Planning and Development
Services of Kenton County

RE: Staff Recommendations for the October 01, 2026, Public Hearing

FILE NUMBER: PC-26-0009-MA

REQUEST: A proposed Map Amendment and Concept Development Plan to the Fort Mitchell Zoning Ordinance (1) changing the described area from BP (Business Park) Zone to PUD (Planned Unit Development) Zone, and (2) a revised Concept Development Plan for a portion of an existing PUD Zone. The applicant proposes an addition to an existing PUD for six rear entry attached single-family residential dwellings fronting Grandview Drive. The total PUD area will be 12.85 acres, have 54 dwelling units, and 48 percent open space (a net density of 4.78 dwelling units per net acre).

INC MODERN FARMHOUSE | EXTERIOR DESIGN

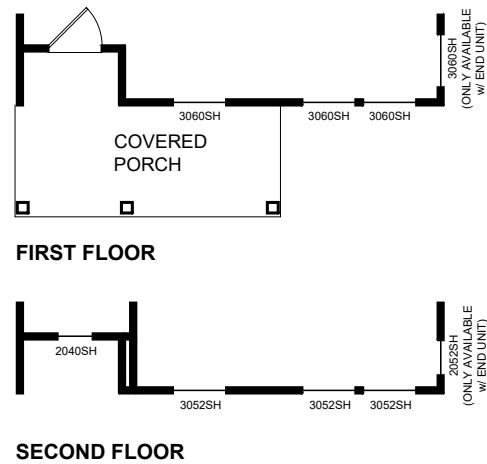
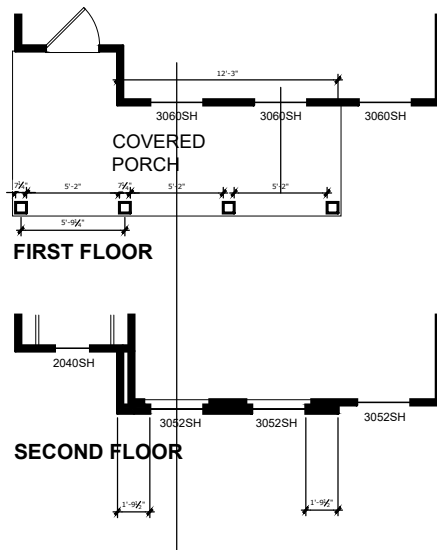
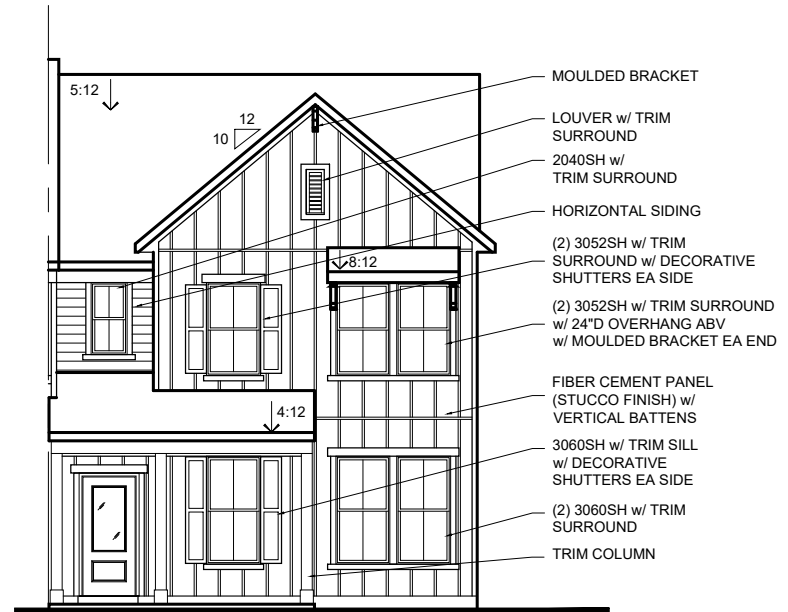
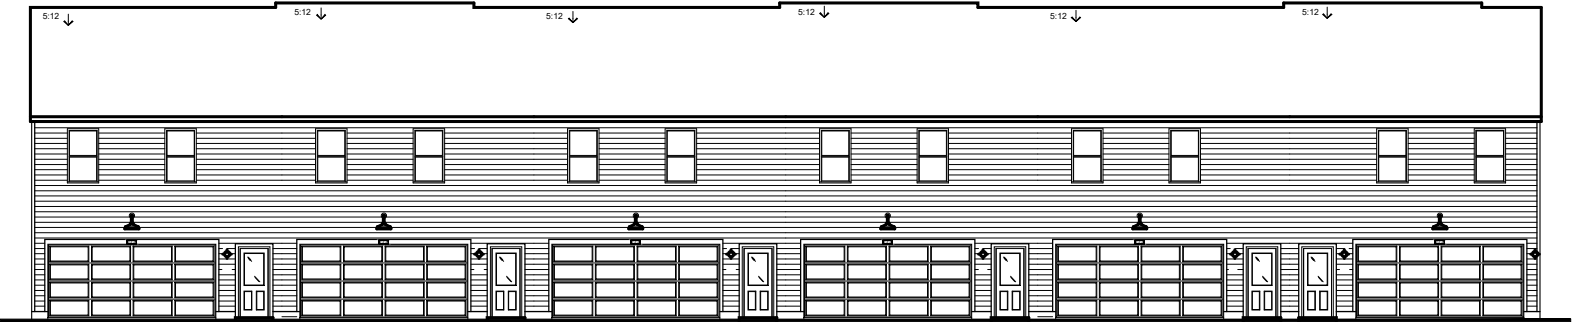
- In the plans submitted for the preapplication it did not include the additional 13 foot area to the north of the existing parcel. Is there a purchase agreement or has there been conversation with that property owner regarding the transfer and/or consolidation of this area?
- What is the plan for trash pick up for these new homes? Will there be a pad or dumpster where the trash will be collected and if so, where will that be located?
- What are the areas that jut out adjacent to the driveways? Are these porches or rear access points?
- Are any elevations available currently? If not that is fine.
- Do you have bedroom counts and estimated price points per unit?

See attached elevations. The area adjacent to the garage doors is the pad for the rear entry door.

Elevations attached.

CONCEPT PLAN/PRELIMINARY PLAT

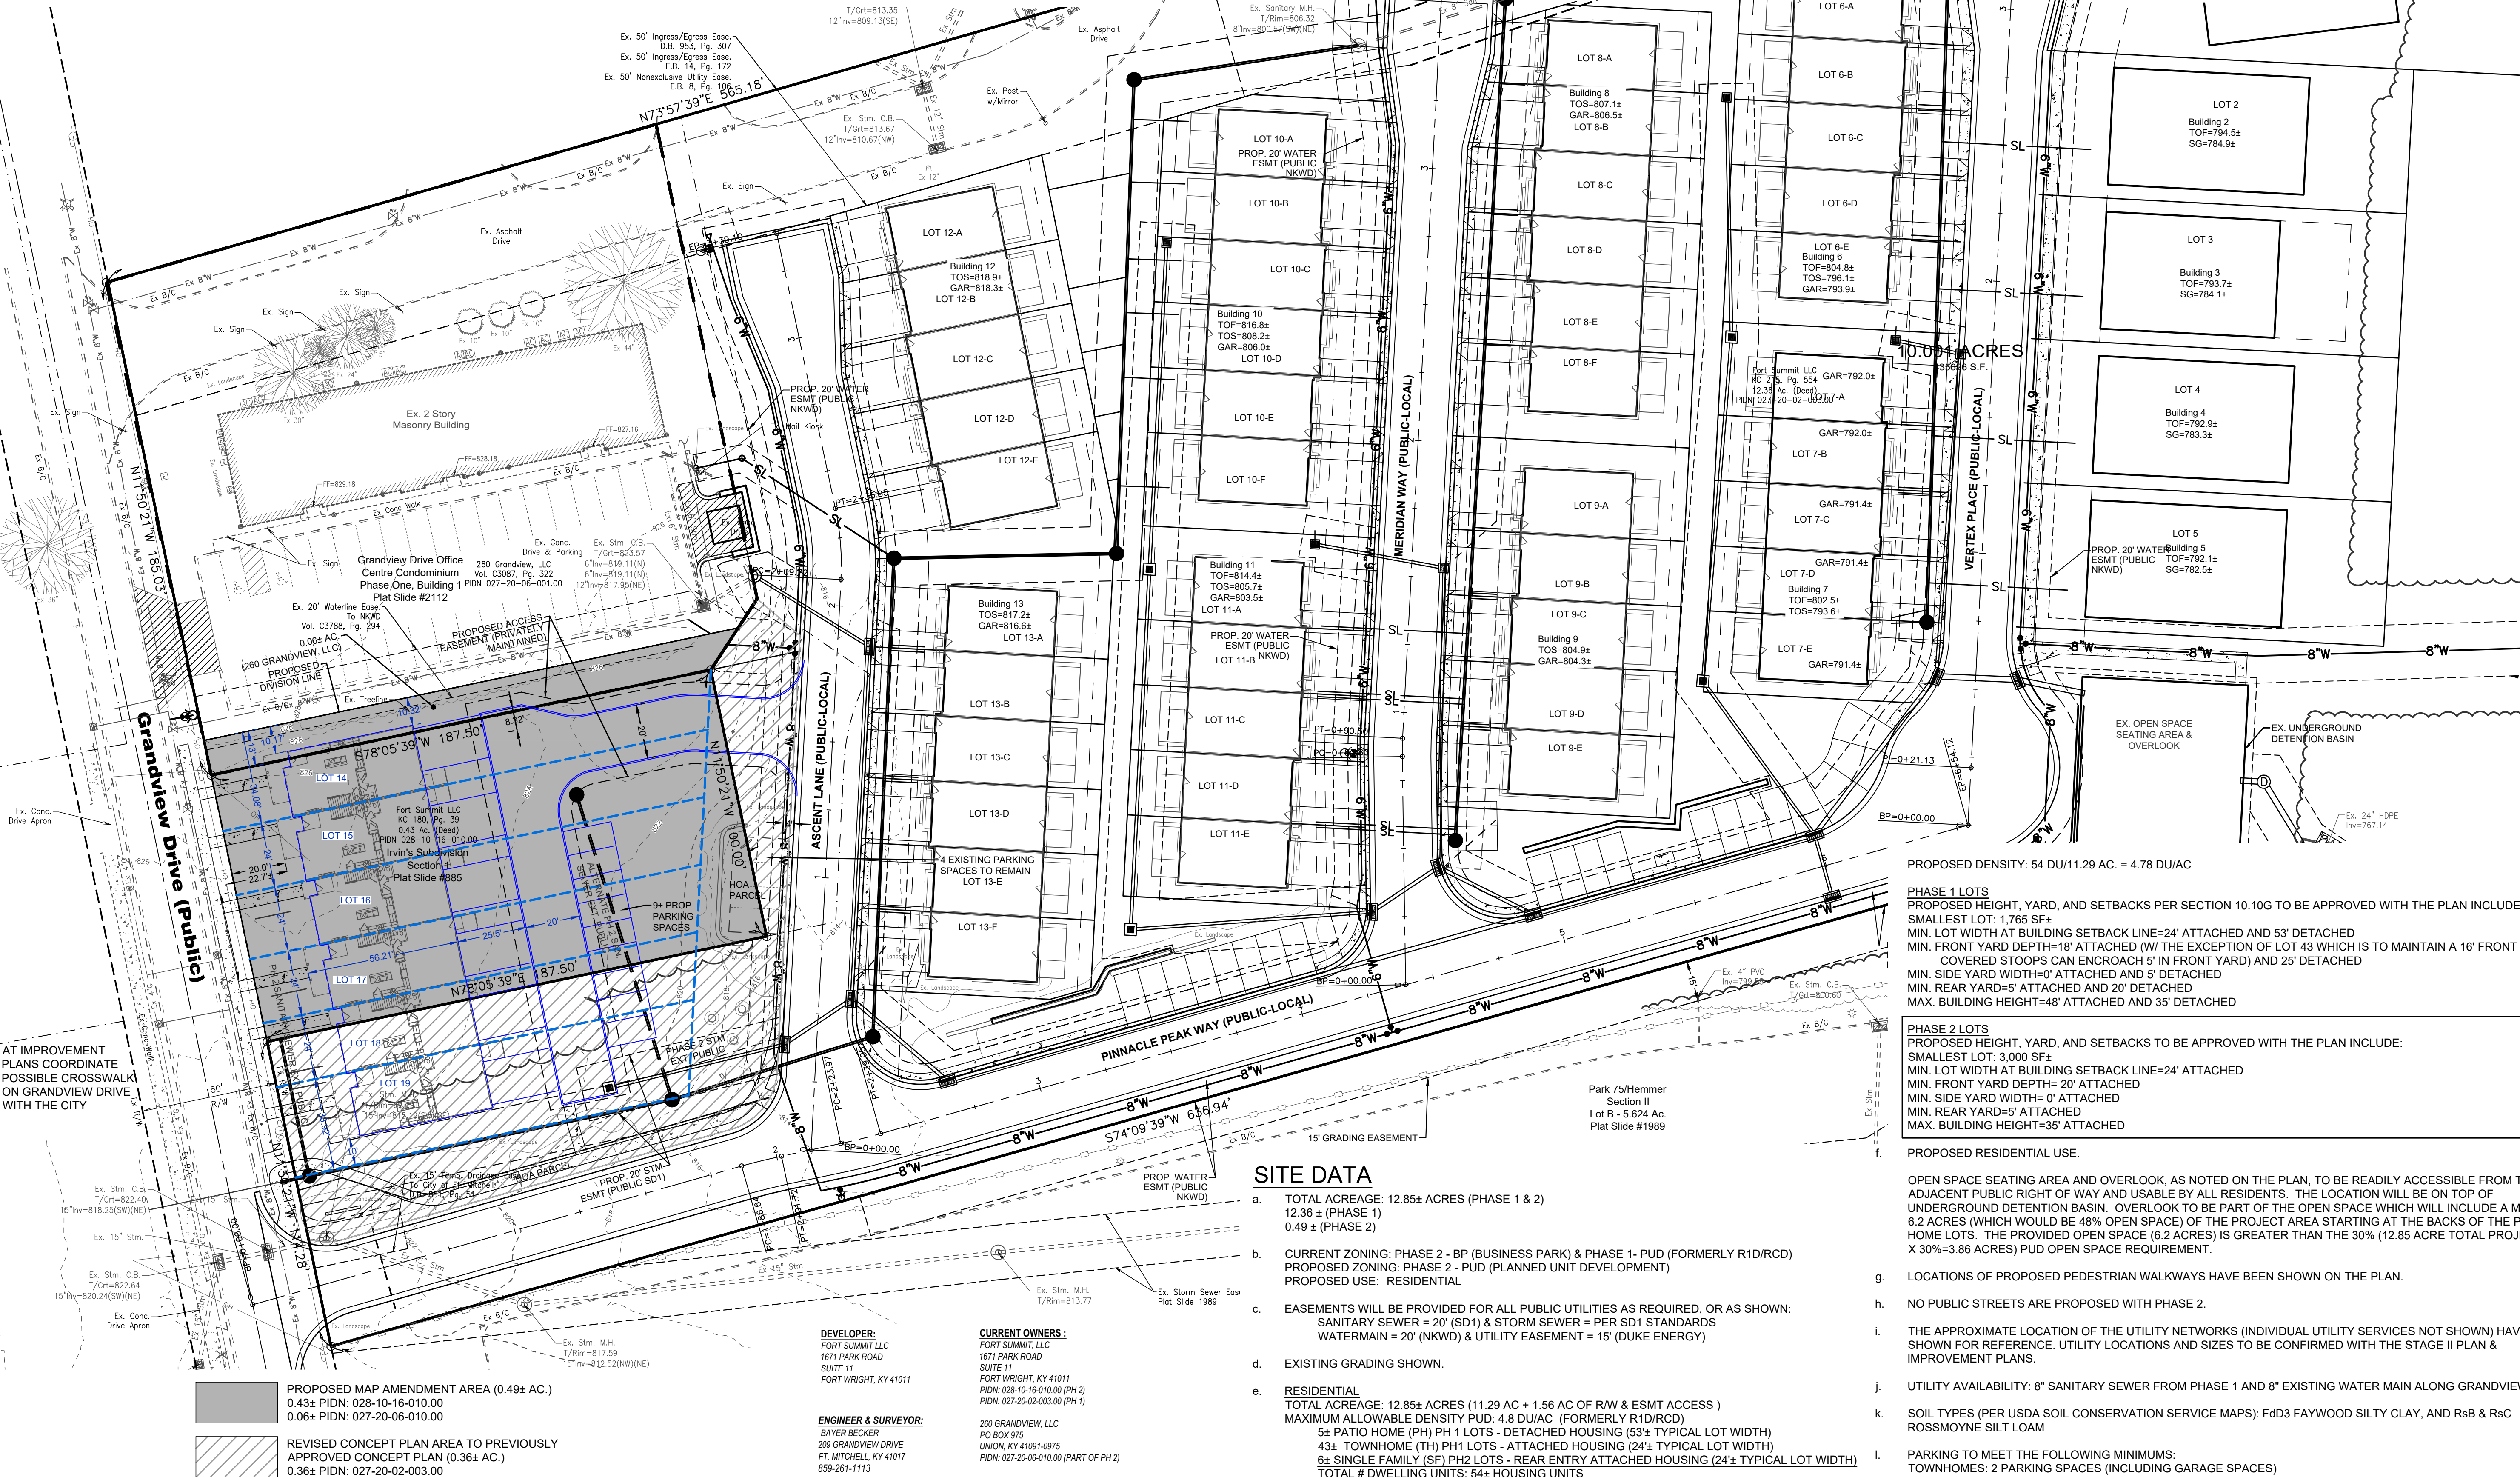
I am working on your Map Amendment and Revised Concept Development Plan for The Pinnacle of Fort Mitchell. Please note that there is a minor issue on the preliminary plat which I've included screenshots of. The Site Data describes Phase 2 as 6+/- Single Family – rear entry detached housing but the Phase 2 lots are described as attached housing and the site plan appears to show attached housing.

Can you please fix this on the preliminary plat?

The attached revised plan corrects the typo, thanks.

- TOTAL ACRES: 12.85± ACRES (PHASE 1 & 2)
12.36 ± (PHASE 1)
0.49 ± (PHASE 2)
- CURRENT ZONING: PHASE 2 - BP (BUSINESS PARK) & PHASE 1- PUD (FORMERLY R1D/RCD)
PROPOSED ZONING: PHASE 2 - PUD (PLANNED UNIT DEVELOPMENT)
PROPOSED USE: RESIDENTIAL
- EASEMENTS WILL BE PROVIDED FOR ALL PUBLIC UTILITIES AS REQUIRED, OR AS SHOWN:
SANITARY SEWER = 20" (SD1) & STORM SEWER = PER SD1 STANDARDS
WATERMAIN = 20" (NKWD) & UTILITY EASEMENT = 15' (DUKE ENERGY)
- EXISTING GRADING SHOWN.
- RESIDENTIAL
TOTAL ACRES: 12.85± ACRES (11.29 AC + 1.56 AC OF R/W & ESMT ACCESS)
MAXIMUM ALLOWABLE DENSITY PUD: 4.8 DU/AC (FORMERLY R1D/RCD)
5± PATIO HOME (PH) PH 1 LOTS - DETACHED HOUSING (53± TYPICAL LOT WIDTH)
43± TOWNHOME (TH) PH1 LOTS - ATTACHED HOUSING (24± TYPICAL LOT WIDTH)
6± SINGLE FAMILY (SF) PH2 LOTS - REAR ENTRY ATTACHED HOUSING (24± TYPICAL LOT WIDTH)
TOTAL # DWELLING UNITS: 54± HOUSING UNITS
